SCIENCE REVIEW OF ADDITIONAL DOCUMENTS SUBMITTED MAY 13–JUNE 17, 2019 FOR THE SECOND TECHNICAL REVIEW OF THE FINAL ENVIRONMENTAL IMPACT STATEMENT ADDENDUM FOR THE BAFFINLAND MARY RIVER PROJECT PHASE 2

This Science Response Report results from the Science Response Process held July 16, 2019 on the Science Review of Additional Supporting and Supplementary Materials for the Final Environmental Impact Statement (FEIS) Addendum for the Baffinland Mary River Project Phase 2.

Figure 1. Example of vessel traffic (colored lines with arrows) and ice coverage (on July 27, 2018) in Baffin Bay and the regional study area of the Mary River Project (from the *Assessment of Icebreaking Operations, Appendix A*, p. 139)

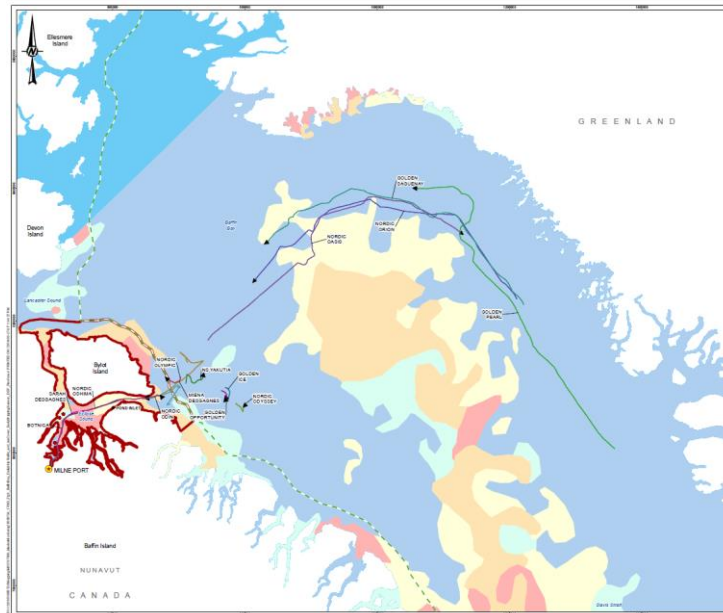
The figure for July 27, 2018 vessel traffic and ice coverage (Figure 1; above) is very concerning to DFO Science as it shows vessels transiting/drifted through areas outside the regional study area (RSA) that are ecologically important to narwhal (*Monodon monceros*), beluga (*Delphinapterus leucas*), bowhead (*Balaena mysticetus*), walrus (*Odobenus rosmarus rosmarus*), seals, and polar bears (Yurkowski et al. 2019a). DFO Science is very concerned that BIM does not provide an assessment of vessel traffic through these ecologically important areas, including the narwhal overwintering area in Baffin Bay and the mouth of Eclipse Sound where vessels and marine mammals will be waiting for ice to recede to enter Eclipse Sound.

Figure 2. Example of modelled listening space reduction (LSR) for two icebreakers and two capsize carriers transiting in compact ice (10/10) at 4.6 knots near Pond Inlet (from Assessment of Icebreaking Operations, Figure 5.3).

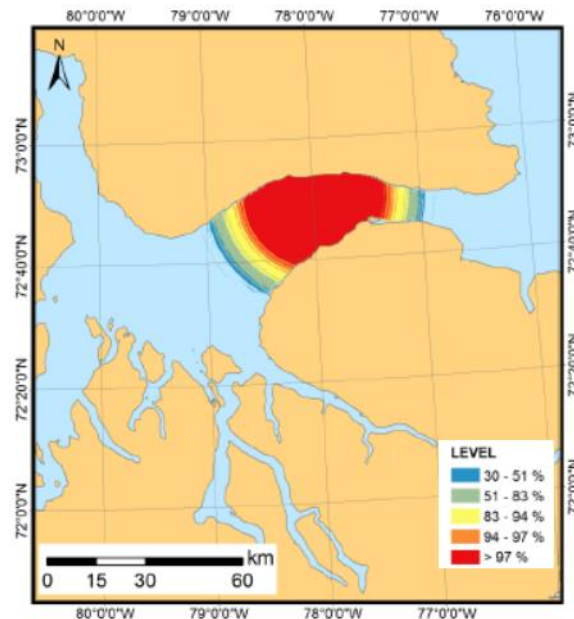
DFO Science requires that BIM provide reference to the data and literature that supports a “*not significant*” rating as DFO does not agree with BIM’s assessment as stated previously (DFO 2019a). DFO Science questions what information exists to suggest noise effects are fully reversible and why are the impacts confined to the LSA when ships will be transiting Baffin Bay. DFO Science requires this information to make a proper assessment.
